Monterey Bay Aquarium Research Institute
7700 Sandholdt Road
Moss Landing, CA 95039
(831) 775-1700 www.mbari.org

Title HE Thruster Wiring Fab, LRAUV Wiring, Build5		Document Number 100221161	Rev E
Size B	Date: Tuesday, February 18, 2025	Engineer Mellinger	Sheet 2 of 15
Design File Q:\DESIGN\DRAWINGS\IEE_DRAWINGS\LRAUV\WIRING\SYSTEM\WIRING\100221189_LRAUV_BUILD5_SYSTEM\WIRING\DRAWINGSET.DSN			
Schematic Name 10021161 BuildInternalWiring		Page Name 02 HE Thruster Wirering Fab	Layout File <Layout File>

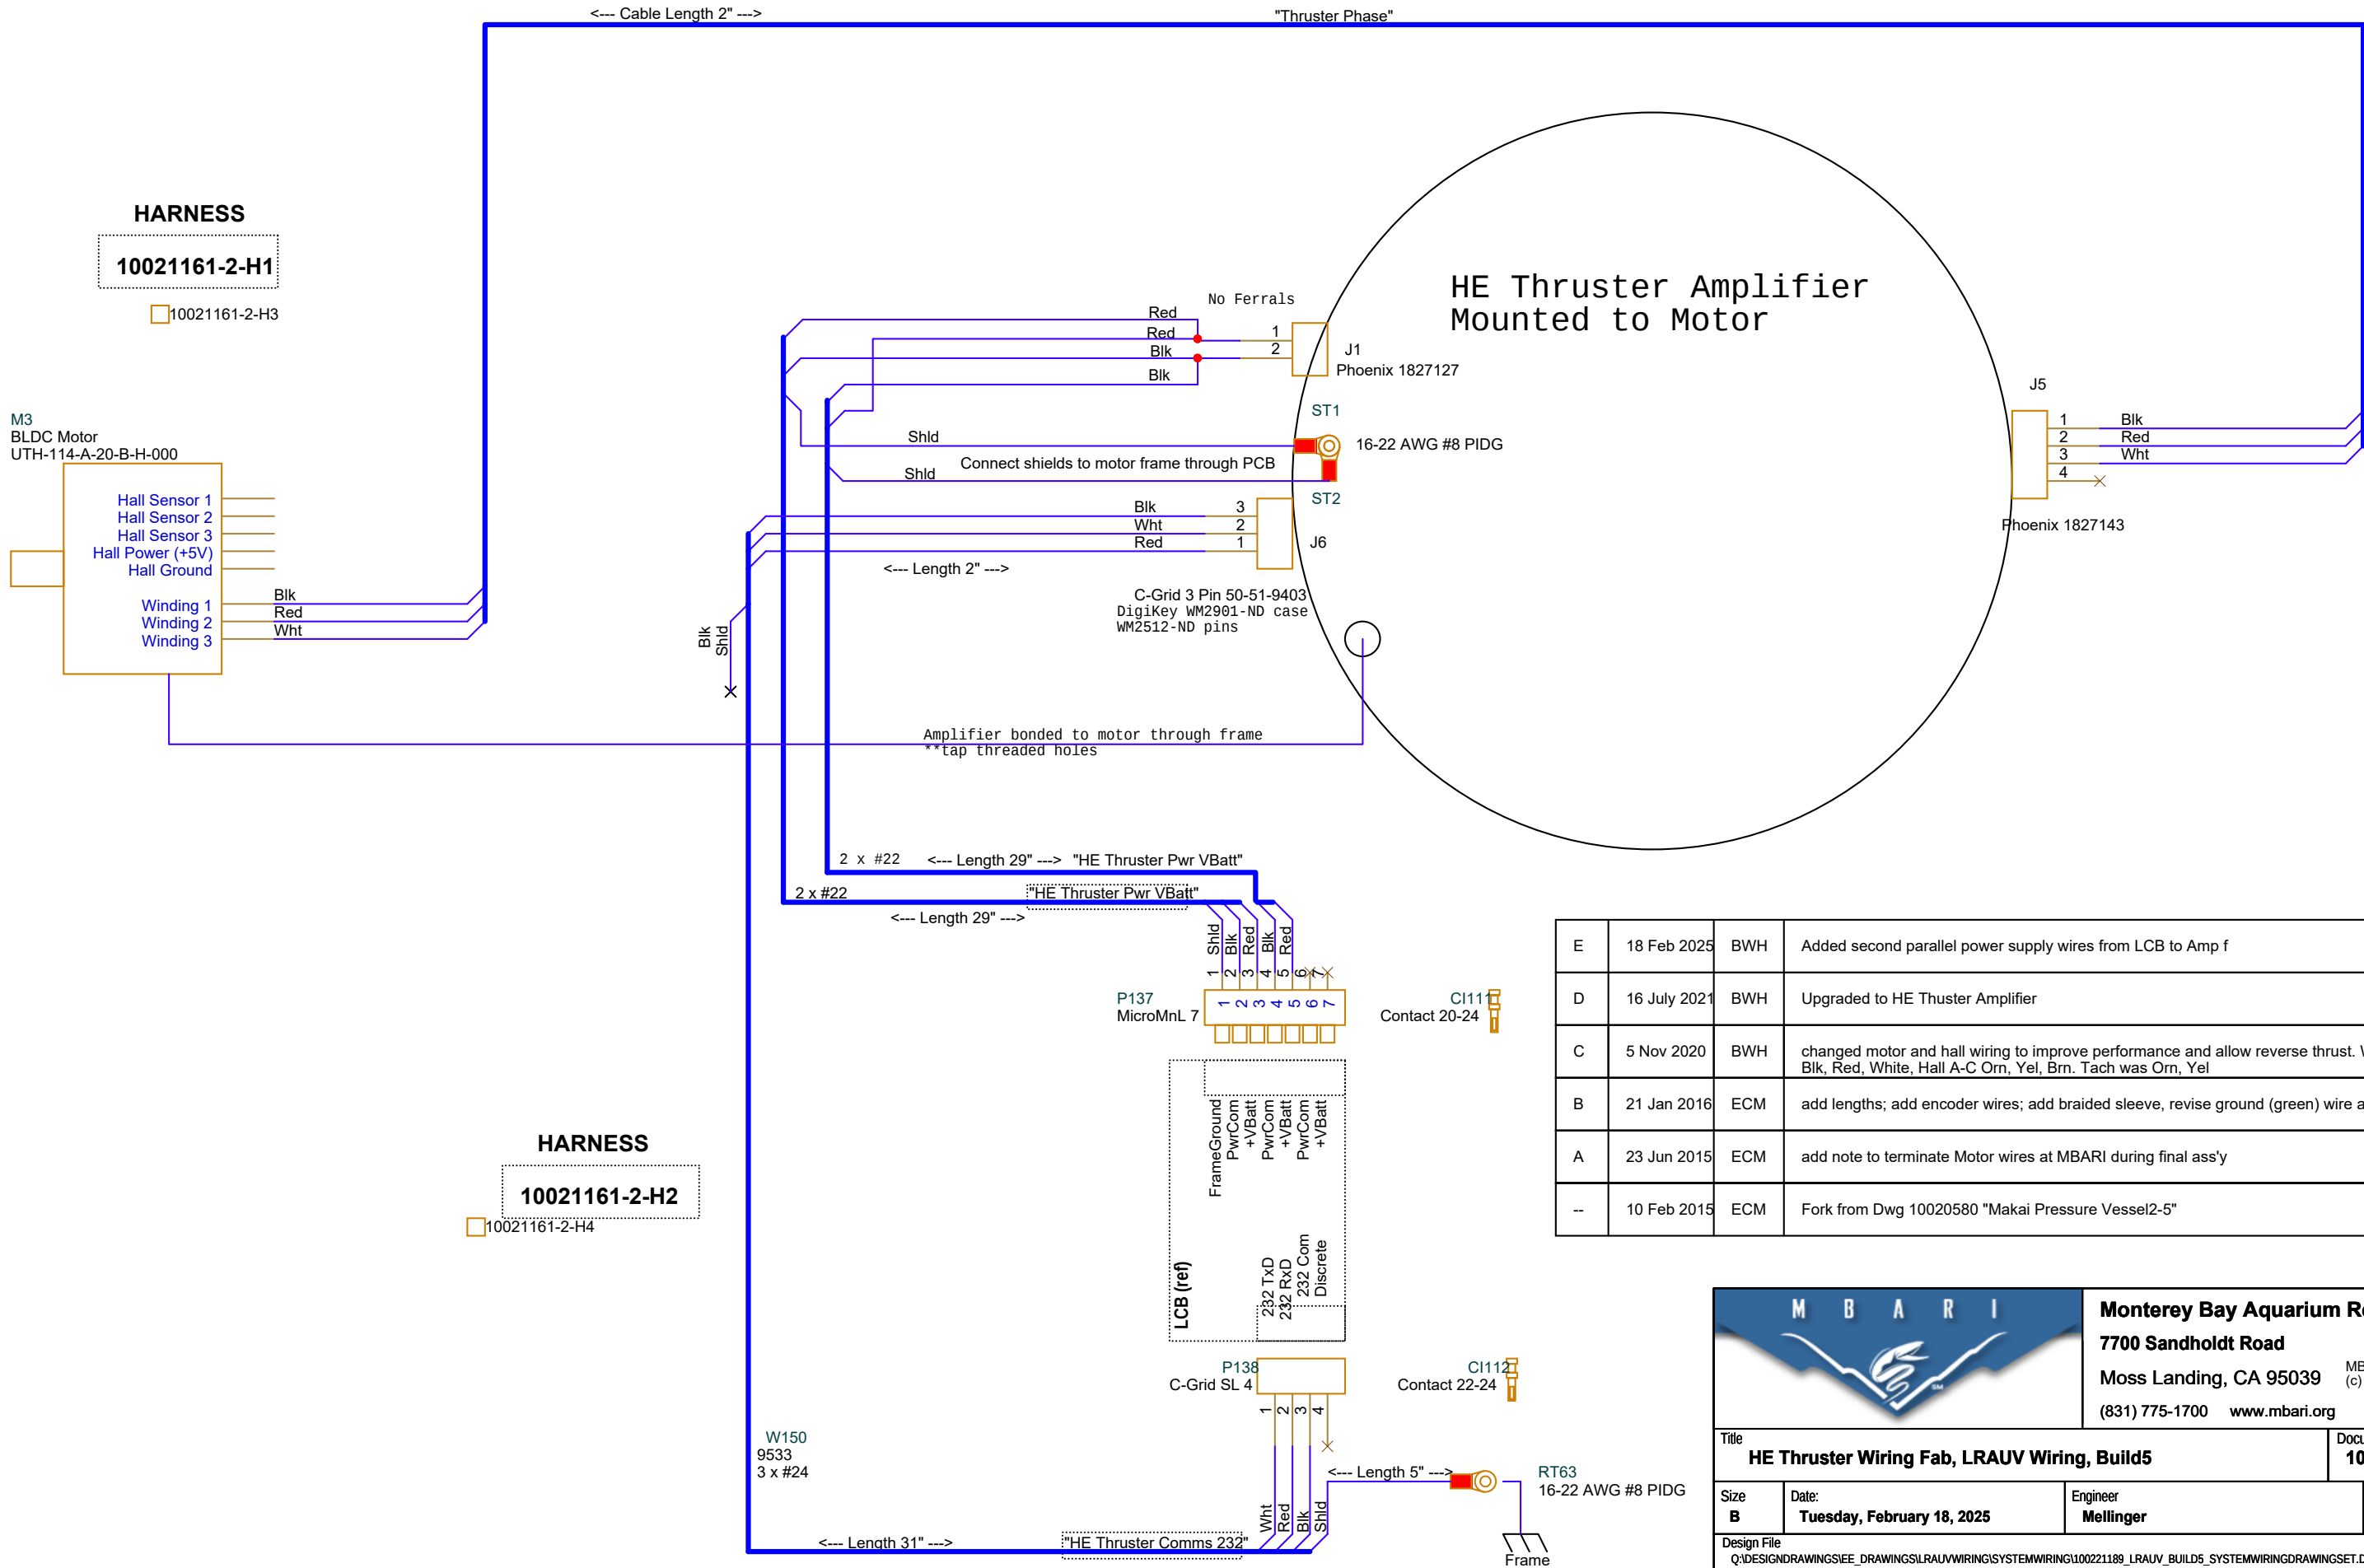
E	18 Feb 2025	BWH	Added second parallel power supply wires from LCB to Amp f
D	16 July 2021	BWH	Upgraded to HE Thruster Amplifier
C	5 Nov 2020	BWH	changed motor and hall wiring to improve performance and allow reverse thrust. Was: Phase A-C Blk, Red, White, Hall A-C Orn, Yel, Brn. Tach was Orn, Yel
B	21 Jan 2016	ECM	add lengths; add encoder wires; add braided sleeve, revise ground (green) wire arrangement
A	23 Jun 2015	ECM	add note to terminate Motor wires at MBARI during final ass'y
--	10 Feb 2015	ECM	Fork from Dwg 10020580 "Makai Pressure Vessel2-5"
